## CONTINUING ELIGIBILITY INSPECTION (CEI) REPORT

FOR FLOOD CONTROL PROJECTS

1. Project Name: Kaunakakai Stream FCP

2. Date of Inspection: October 30, 2002

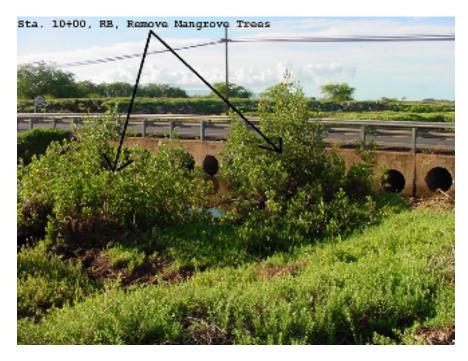
c. Sta. 23+00, LB, remove juvenile tree from the townside sideslope of the levee.

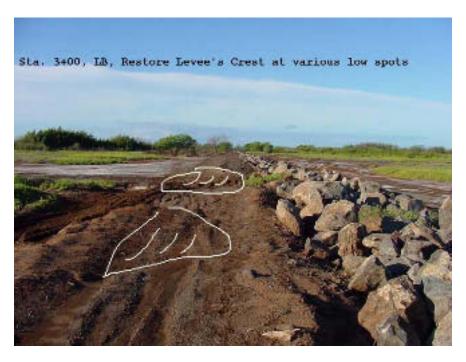
g. Sta. 10+00, RB, remove mangrove trees from toe of levee.
